# 1964 Corvette: Service Bulletin: Neutral Safety Switch Malfunction

**Source:** Chevrolet Technical Service Bulletin

**Bulletin No:** DR #658

**Date:** March 10, 1964

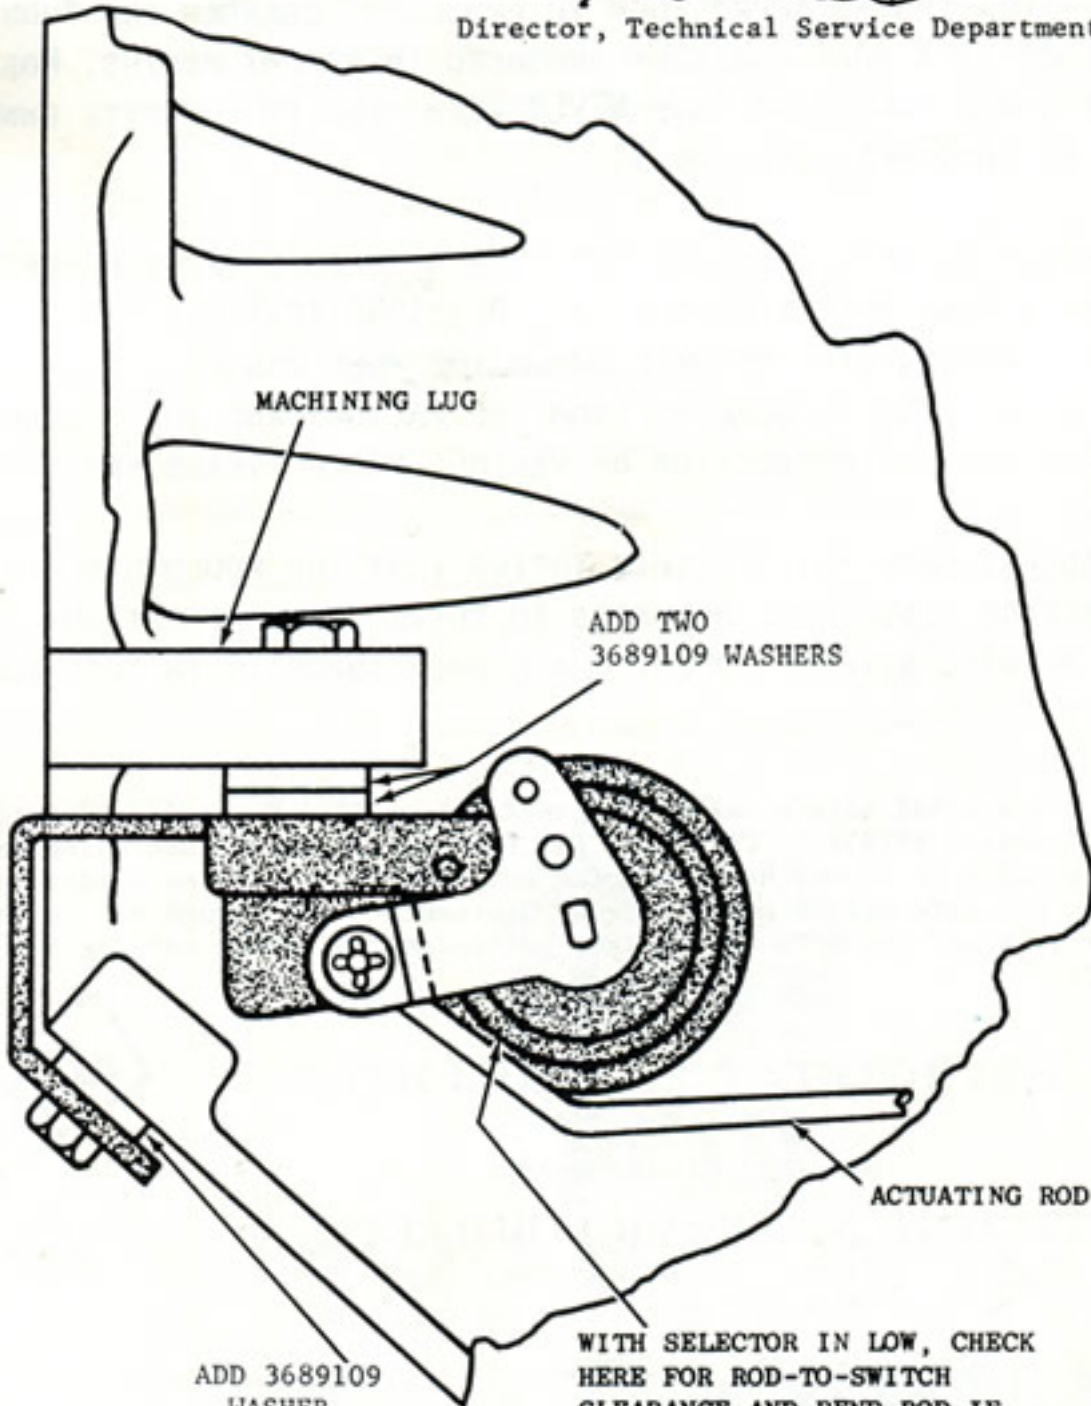
Interference between the neutral safety switch and the underbody may exist on some early production Corvette Models with Powerglide transmissions.

This could result in the engine being started while the transmission selector is in a drive position. In addition, the added load imposed on the shift linkage by the misalignment causes a reduction or loss of detent feel when the transmission is shifted manually. The transmission might then be accidentally operated between ranges and internal damage could result.

Correction of switch malfunction may be made by shimming the switch assembly downward as shown in the attached sketch. Note that operating clearance must exist between the switch body and the switch actuating rod after the shimming operation is completed.

WITH SELECTOR IN LOW, CHECK  
HERE FOR ROD-TO-SWITCH  
CLEARANCE AND BEND ROD IF  
NECESSARY. TEST ACTION OF SWITCH  
AFTER BENDING ROD & ADJUST LENGTH  
OF ROD AS REQUIRED BY TURNING  
THREADED PIVOT.
